ALLAMAKEE CSD MIDDLE SCHOOL HVAC UPGRADE
WAUKON, IOWA

ADDENDUM 01
March 2, 2026

DEMO MECHANICAL & ELECTRICAL PLAN - AREA B
1/8" = 1'-0"

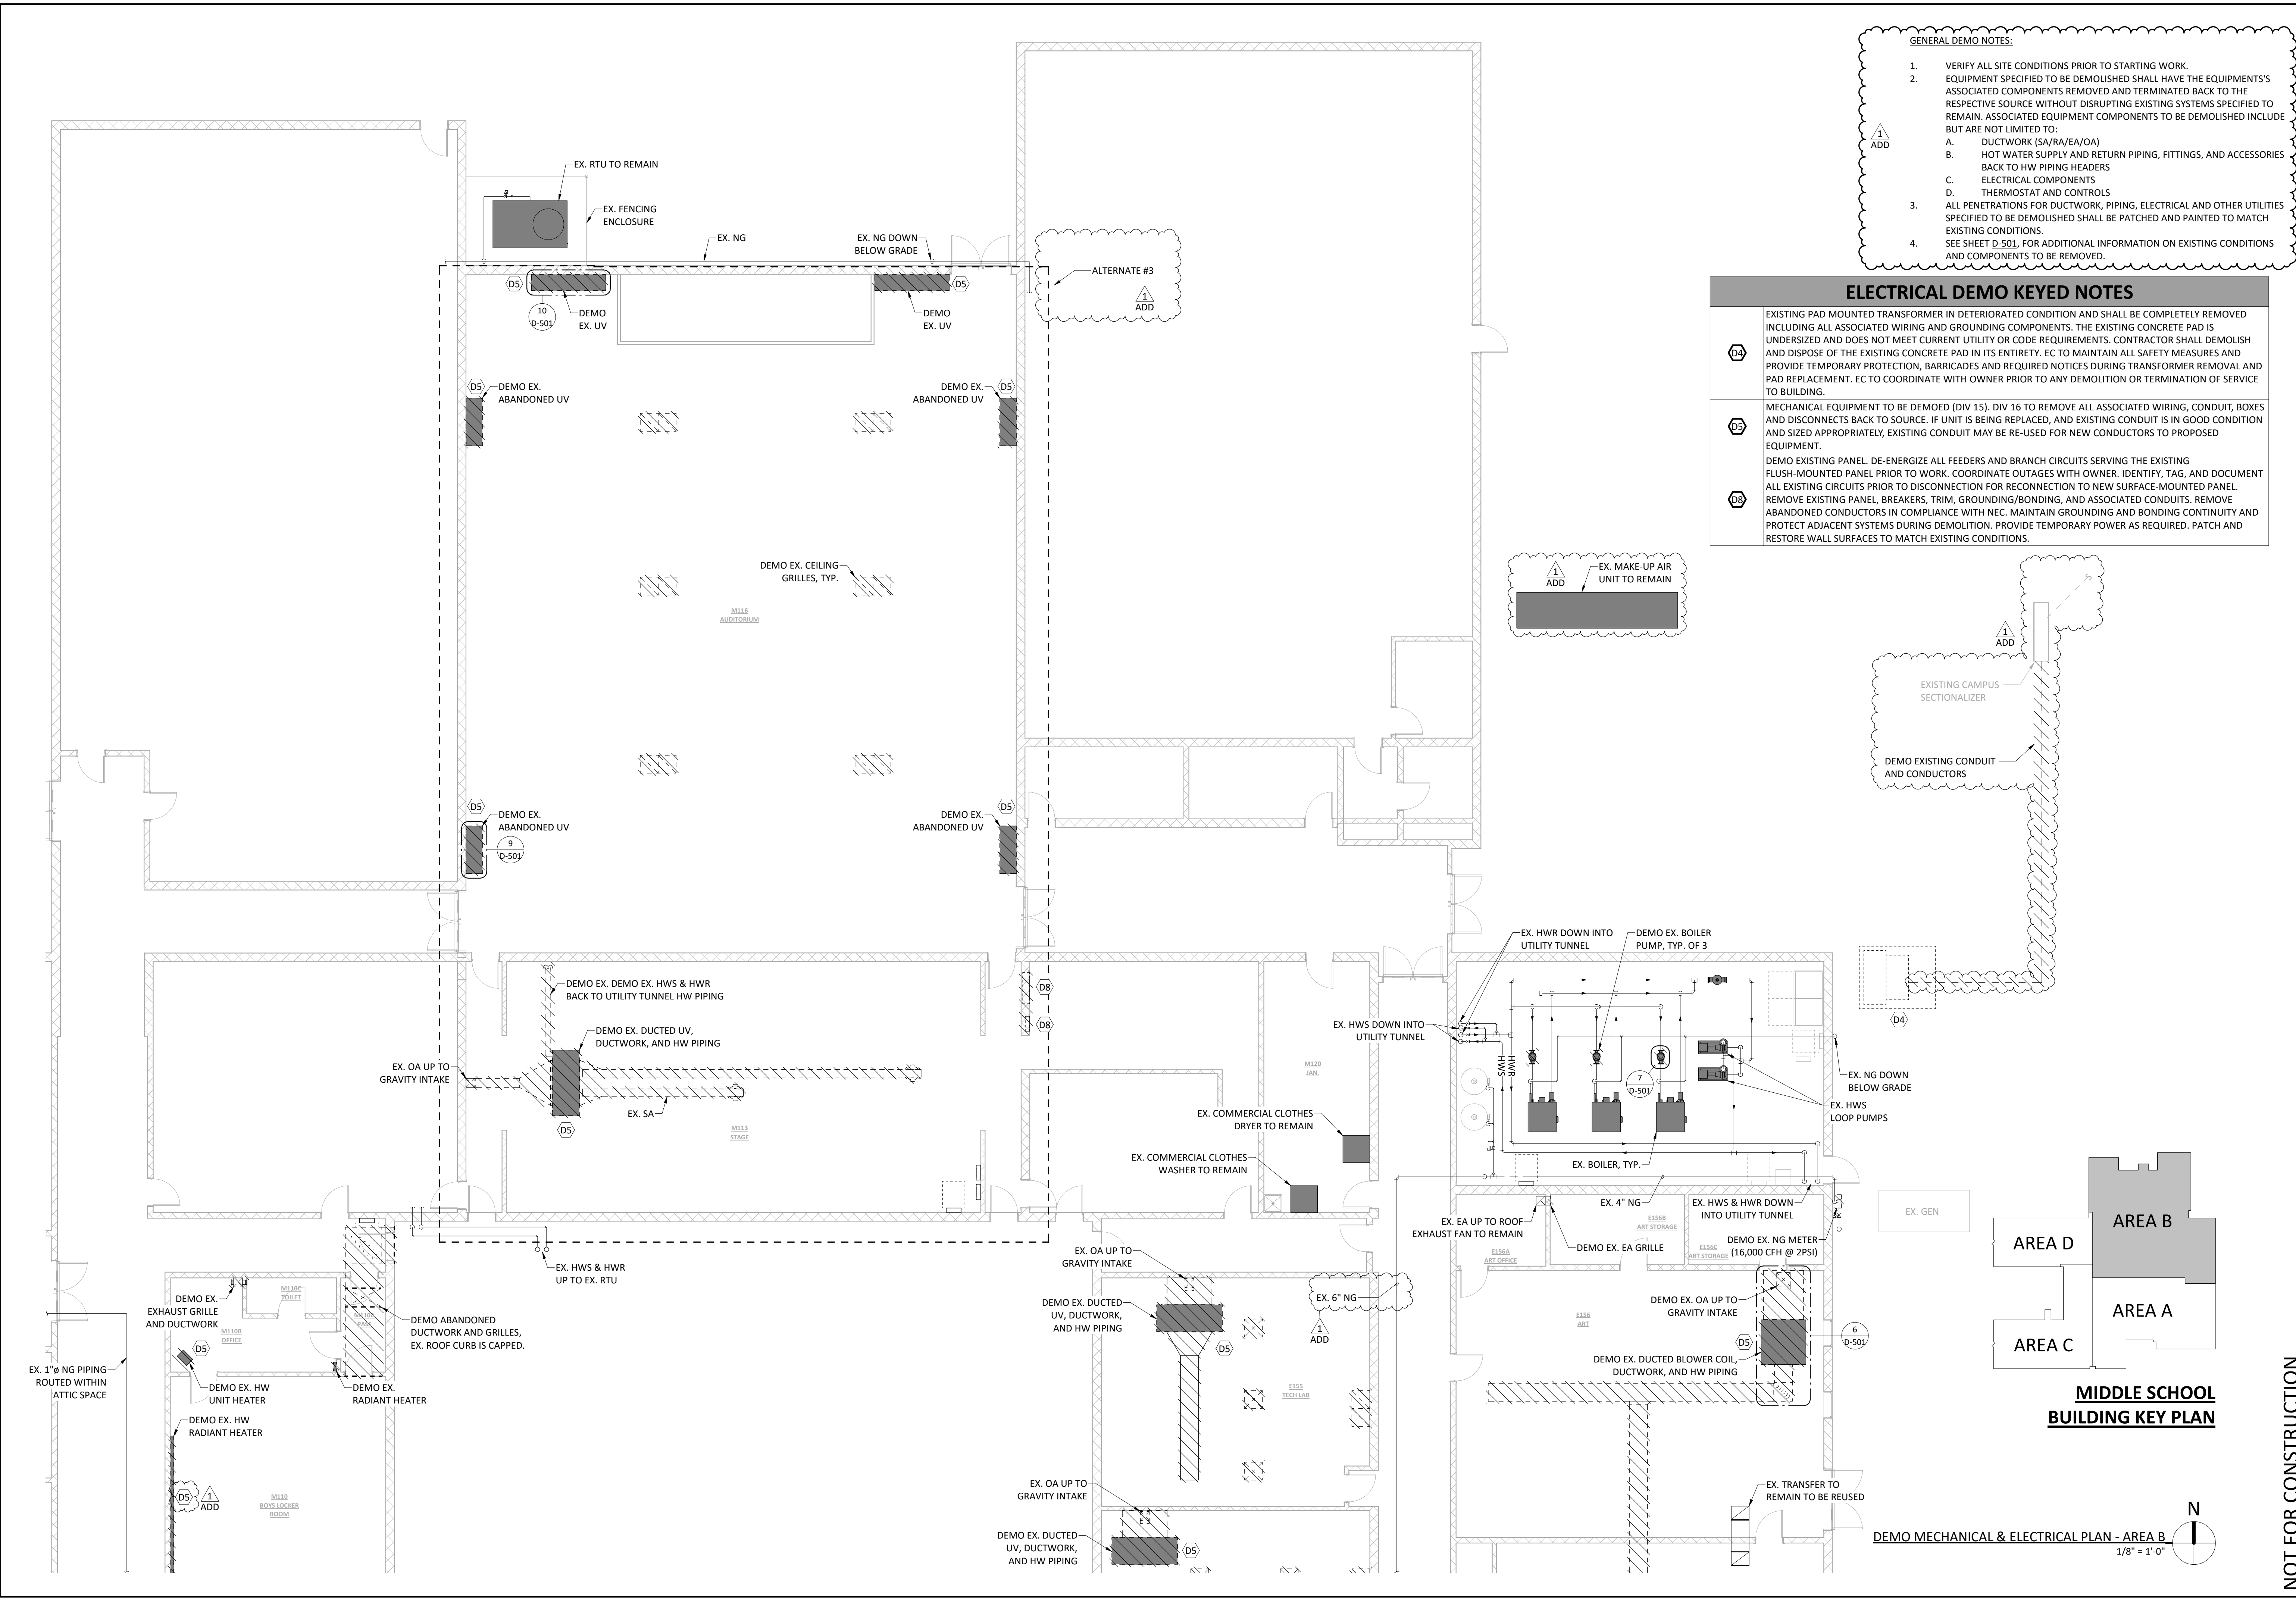
- D1-2 Drawing **D-101B – DEMO MECHANICAL & ELECTRICAL PLAN – AREA B**
1. Added general demo notes.
 2. Added the demolition of existing conduit and conductors to the existing campus sectionalizer.

3. Added electrical demo keynote D5 to existing HW radiant heater.
- D1-3 Drawing **D-110 – DEMO LIGHTING PLAN – OVERALL**
1. Added the demolition of all existing light fixtures and controls in admin area and added a note describing this.

DEMOLITION PLAN - AREA A
1/8" = 1'-0"

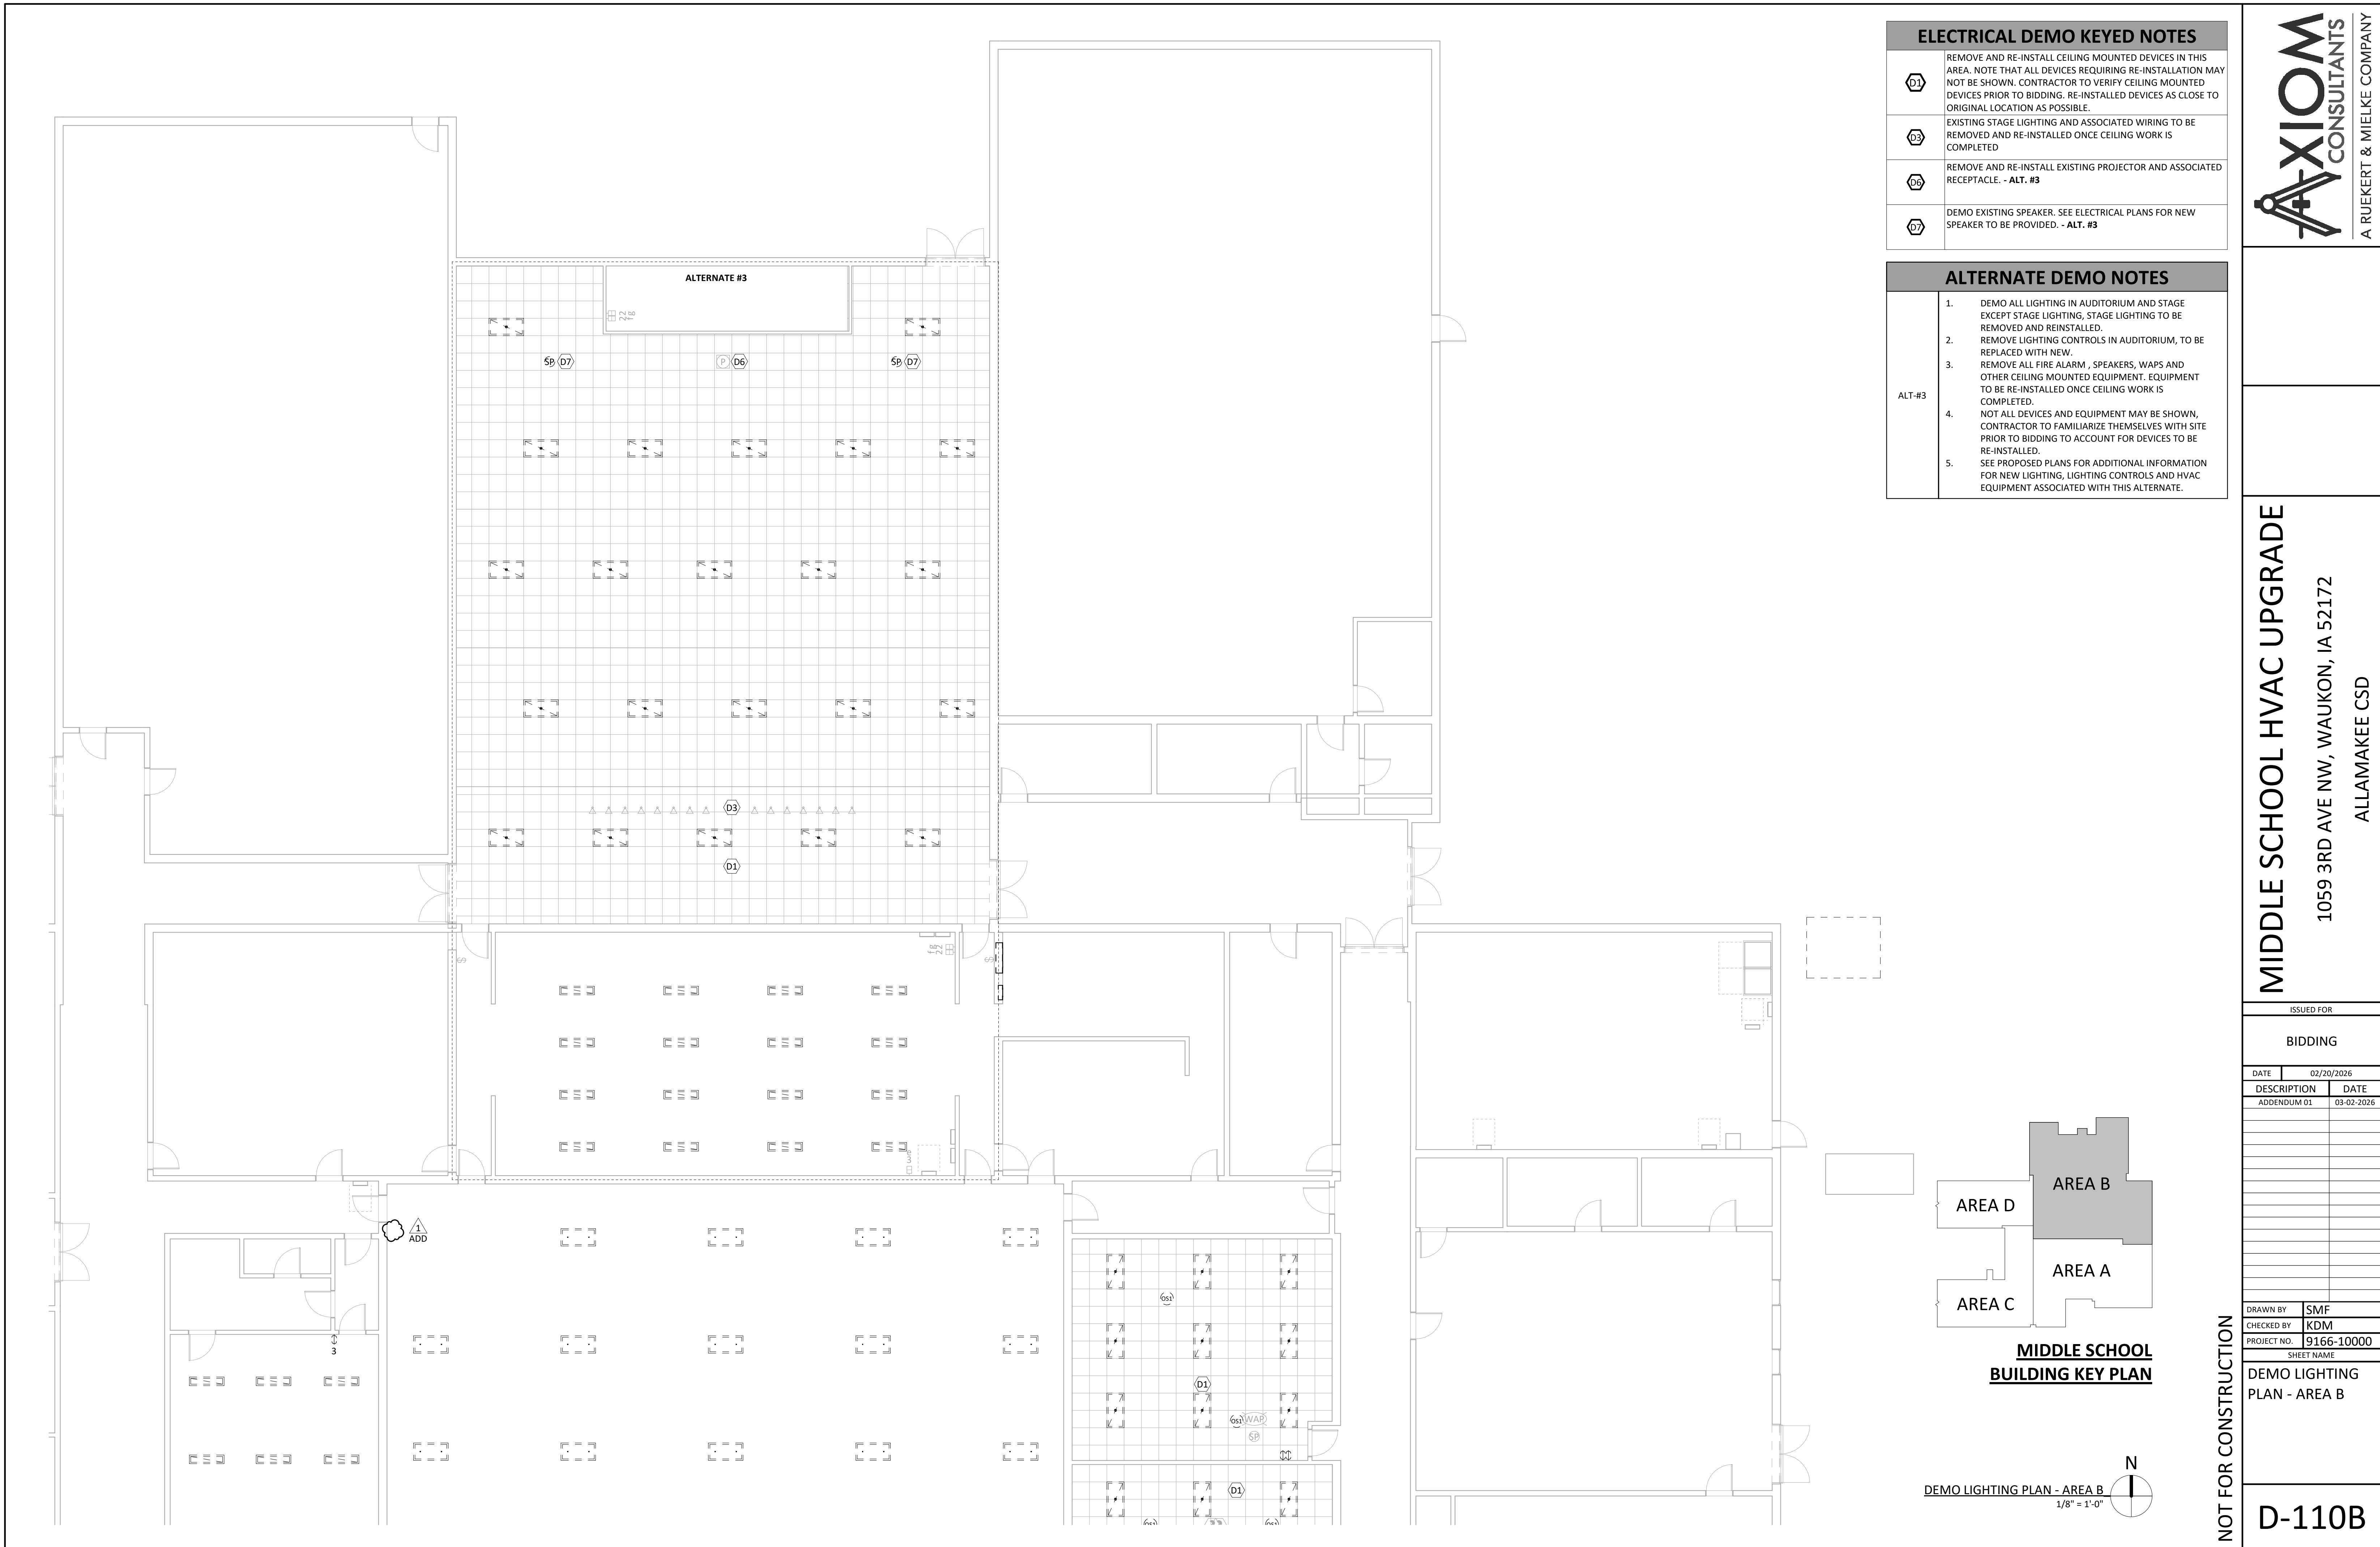
- D1-4 Drawing **D-110A – DEMO LIGHTING PLAN – AREA A**
1. Added the demolition of a light switch in the boy's locker room.
 2. Removed demolition of light switches on south wall of gymnasium.

3. Added the demolition of cafeteria ceiling mounted round speakers.
 4. Removed the demolition of ceiling mounted occupancy sensors in the kitchen.
 5. Added the demolition of all existing light fixtures and controls in admin area.

M-101A

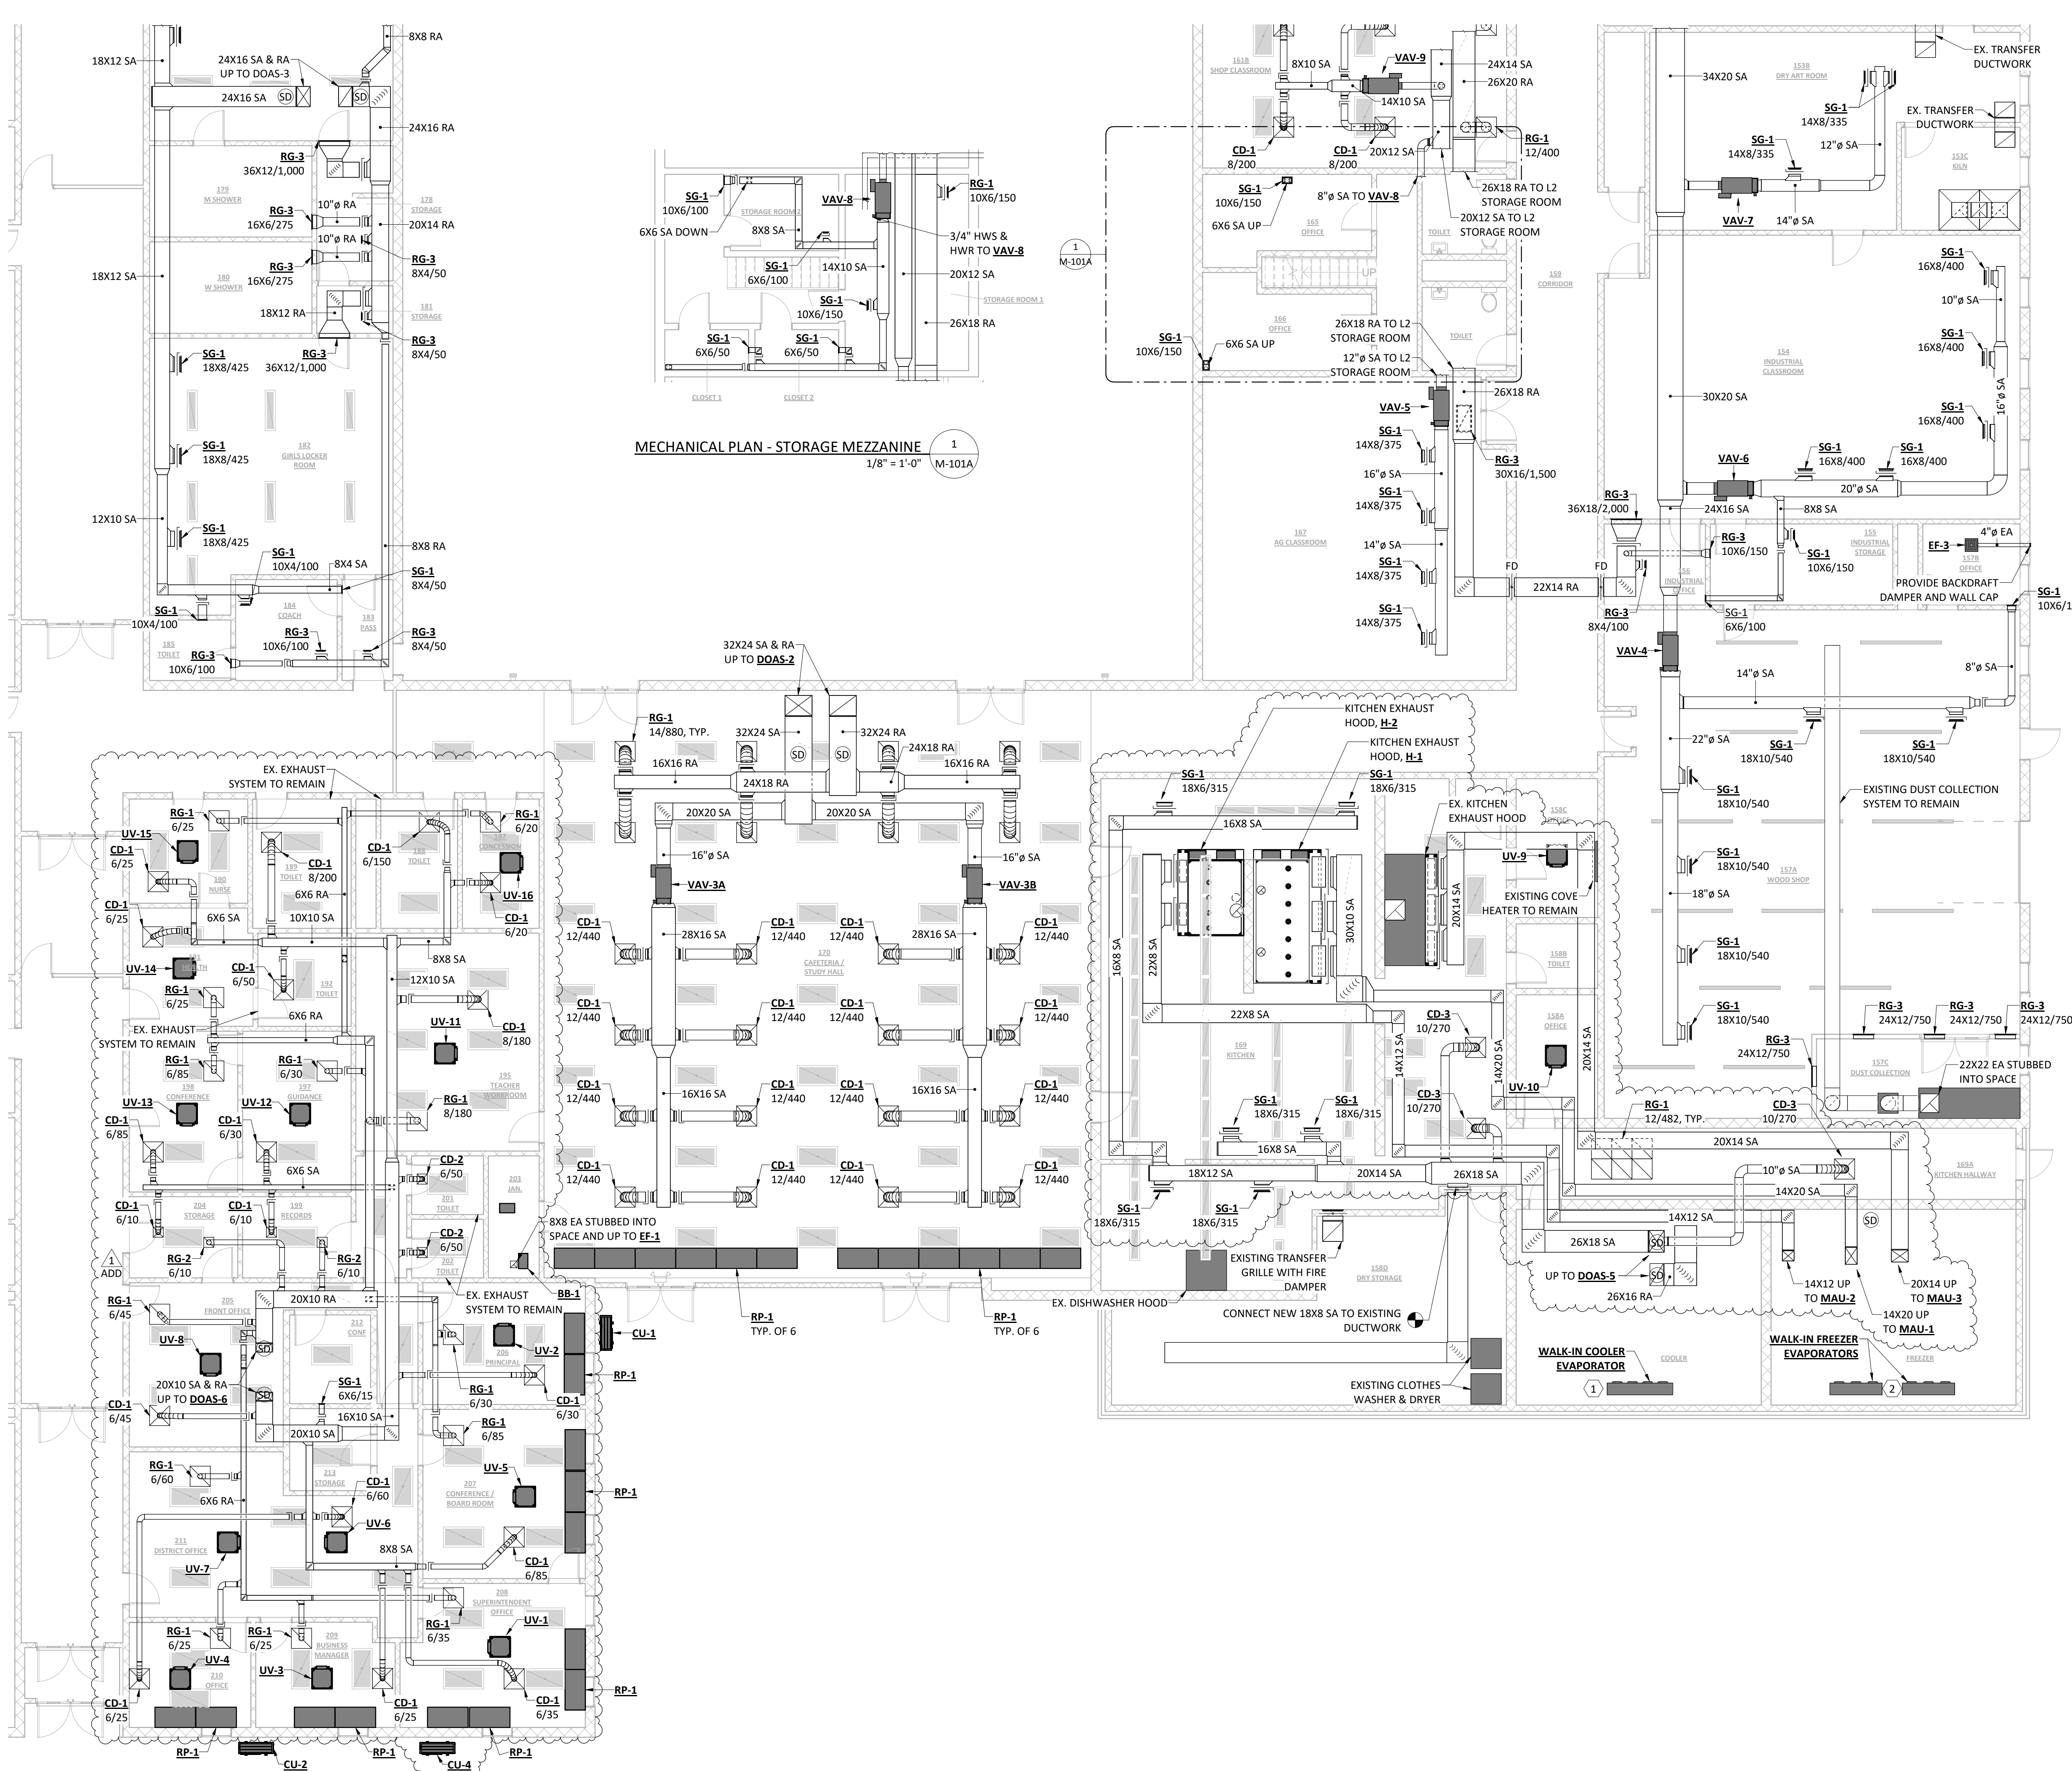
1. Added electrical demo keynote D5 to existing walk-in cooler condensers above the kitchen.
- M1-1 Drawing **M-101A – MECHANICAL PLAN – AREA A**
1. Added remaining Admin spaces and offices to DOAS-6 system and added mini-split systems to provide heating and cooling to the associated spaces.

2. Removed VAV-1 and VAV-2.
 3. Revised kitchen hood makeup and associated ductwork to be provided by individual makeup air units MAU-1, MAU-2, and MAU-3 (one per cooking exhaust hood).

4. Revised UV-9 to be ceiling cassette style unit ventilator.
- M1-2 Drawing **M-101B – MECHANICAL PLAN – AREA B**
1. Relocated humidistat for DH-1 to DOAS-1 return ductwork.
